# Access Compliance Report

## Public Rights-of-Way

Intersection ID: 24549	Main Street: I-485_RA	Cross Street: SOUTH_BV	Location: E
ADA ID: DC4FD6E4AEF4	Ramp Type: BlendTrans1	Initial Pass/Fail: Fail	Overall Compliance: No
Severity Score: 12.5			
Codes/Mitigation Info/Possible Solution		Field Measurements/Component Compliance

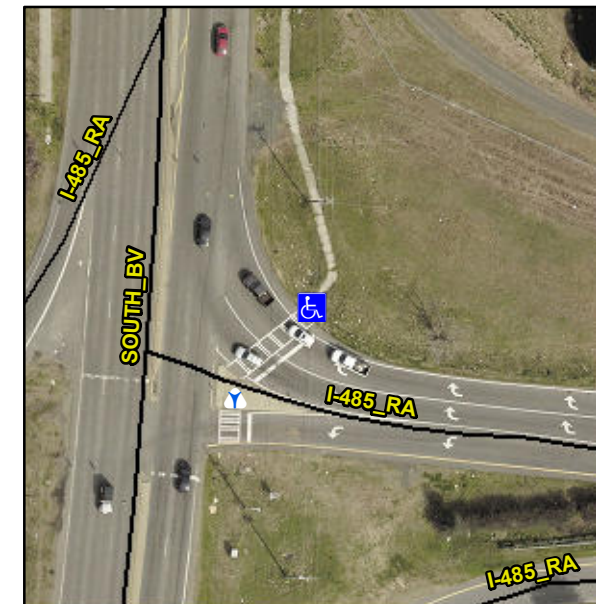
**Not Found, R304.5.3**

Compliance	Description	Data	Compliance	Description	Data
N/A	Ramp Length (in)	40.0	Yes	BlendTrans Slope (%)	1.3
Yes	Ramp Width (in)	60.0	No	BlendTrans XSlope (%)	5.6
N/A	Flare Type LT	N/A	N/A	Flare Type RT	N/A
N/A	Flare Slope LT (%)	N/A	N/A	Flare Slope RT (%)	N/A
N/A	Flare Traversable LT?	N/A	N/A	Flare Traversable RT?	N/A
N/A	Landing Length (in)	N/A	N/A	DWS Provided?	N/A
N/A	Landing Width (in)	N/A	N/A	DWS Contrast?	N/A
N/A	Landing Slope (%)	N/A	N/A	DWS Length (in)	N/A
N/A	Landing X Slope (%)	N/A	N/A	DWS Full Width?	N/A
N/A	Landing Curb? (Y/N)	N/A	N/A	DWS Offset (in)	N/A
N/A	Shared Landing?	N/A			
N/A	Gutter Ponding?	N/A	N/A	Gutter Slope (%)	N/A
N/A	Gutter Lip Ht (in)	N/A	N/A	Gutter X Slope (%)	N/A
N/A	Painted X Walk1?	Yes	N/A	Painted X Walk2?	N/A
	X Walk 1 Direction	To SW		X Walk 2 Direction	N/A
	X Walk 1 Width (in)	110.0		X Walk 2 Width (in)	N/A
	X Walk 1 Slope (%)	3.4		X Walk 2 Slope (%)	N/A
	X Walk 1 X Slope (%)	3.0		X Walk 2 X Slope (%)	N/A

N/A	Ramp inside XWalk1?	Yes	N/A	Ramp inside XWalk2?	N/A
	Road Slope (%)	3.0		Clear Space?	N/A
	Road X Slope (%)	3.4	N/A	Clear Space to XWalk (in)	N/A
N/A	Any Obstructions?	N/A	N/A	Storm Grate/Utility Hazard?	N/A
	Obstruction Type			Storm Grate/Utility Type	
		N/A			N/A
			Yes	Surface Condition? (G/P)	Good
			No	Curb Slope (%)	8.4

**Remove & Replace Curb Ramp With Two New Directional Ramps or Equivalent.**
